Resolution No. 61, “Recommendations on Harmonized Europe-Wide Technical Requirements for Inland Navigation Vessels”

Amendments to Chapter 15, «Special provisions for passenger vessels»

Note by the secretariat

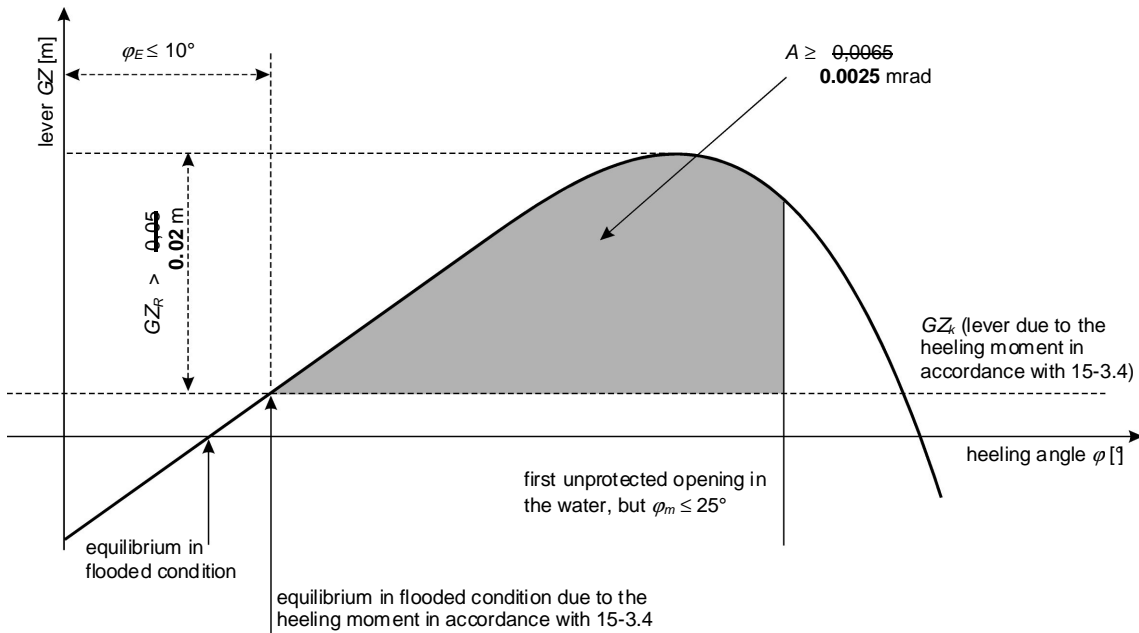
(i) ~~assumed dimensions of damages applicable to 1-compartment status and 2-compartment status are stated in the table below:~~

<i>1-compartment status</i>	<i>2-compartment status</i>
<i>Dimension of the side damage</i>		
longitudinal l [m]	$1.20 + .07 \cdot L_{WL}$ $0.10 \cdot L_{WL}$, however not less than 4,00 m	$1.20 + .07 \cdot L_{WL}$ $0.05 \cdot L_{WL}$, however not less than 2,25 m
transverse b [m]	$B/5$	0,59
vertical h [m]	from vessel bottom to top without delimitation	
<i>Dimension of the bottom damage</i>		
longitudinal l [m]	$1.20 + .07 \cdot L_{WL}$ $0.10 \cdot L_{WL}$, however not less than 4,00 m	$1.20 + .07 \cdot L_{WL}$ $0.05 \cdot L_{WL}$, however not less than 2,25 m
transverse b [m]	$B/5$	
vertical h [m]	0,59; pipe work installed according to 15-2.13 (iii), shall be deemed intact

~~The calculation of free surface effect in intermediate stages of flooding shall be based on the gross surface area of the damaged compartments.~~

(i) For 1-compartment status the bulkheads can be assumed to be intact if the distance between two adjacent bulkheads is greater than the damage length. Longitudinal bulkheads at a distance of less than $B/3$ from the outer plating measured perpendicular to centre line from the shell plating at the maximum draught shall not be taken into account for calculation purposes;

(ii) For 2-compartment status, each bulkhead within the extent of damage, will be assumed to be damaged. The vessel shall remain buoyant after flooding;

(iii) The lowest point of every non-watertight opening (e.g. doors, windows, access hatchways) shall lie at least 0.10 m above the damaged waterline. The bulkhead deck shall not be immersed in the final stage of flooding;

(iv) Permeability is assumed to be 95%. If it is proven by a calculation that the average permeability of any compartment is less than 95%, the calculated value can be used instead;
